COMMUNICATION from the City Plan and Zoning Commission advising that at a public hearing held February 7, 2008, the members voted 11-1 in support of a motion to **APPROVE** the request from Chris and Christie Hayes (owners) for approval of a preliminary subdivision plat "Hayes' Addition to Capitol Heights Plat No. 2" to allow division of the property into two lots for single-family residential use, for property located at 4353 NE Aurora Avenue in unincorporated Polk County within the City's two-mile extraterritorial jurisdiction for subdivision review, subject to the following conditions:

RE: Preliminary Plat, Hayes' Addition to Capitol Heights Plat No. 2.

HAYES' ADDITION TO CAPITOL HEIGHTS PLAT NO. 2

PRELIMINARY PLAT

HAYES' ADDITION TO CAPITOL HEIGHTS PLAT NO. 2

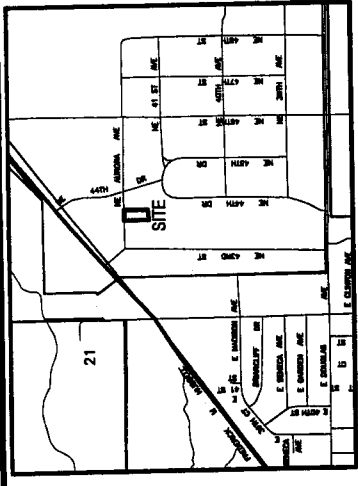
1. Legal Description—According the Polk County Recorder's Office, the original of the official plat has the title "CAPITOL HIEGHTS NO. 2", not "CAPITOL HEIGHTS PLAT NO. 2".

2. Surveyor/Engineer Certification—Preliminary plats in Des Moines are also required to be certified by an engineer licensed in Iowa.
3. Subsurface Features—The nearest sanitary sewer is more than 600 feet to the north in Hubbell Avenue. In the City of Des Moines, neither lot 1 (area 15,037 square feet or 0.345 acres), nor lot 2 (area 33,211 square feet or 0.762 acres) would comply with the requirements for Municipal Code Section 106-132 Platting of land (3) Lot Design "g. Any lot not served by sanitary sewer shall have a lot area of not less than one acre". Check with Polk County as to the lot area requirement and the use of a peat filter system for the sanitary sewer treatment.

4. General Comments—The adjoining property to the west is in a different subdivision—show it on the plat.

Show the name of the adjoining subdivision to the east and south of the plat.

Only a portion of lot 26 adjoins this plat to the west—show an abbreviated description.

5. The final copy of the plat will need the certification statement signed and dated.
6. According to the City of Des Moines Subdivision Ordinance, all trees 6" caliper or larger shall be clearly identified (species, caliper size) on the preliminary plat.
7. Show the Polk County-assigned parcel address for Lot 2. Also, the address shown for the existing lot in the plat notes section is incorrect (it reads 4553 NE Aurora Avenue, rather than 4353 NE Aurora Avenue).
8. While notation is giving on the plat, staff cannot find the location of a private sewage disposal system (septic or "existing peat filter system") on the plat map. Show the location of existing and proposed septic fields to ensure that a portion of a septic field does not encroach into neighboring property, or the lot to be subdivided.
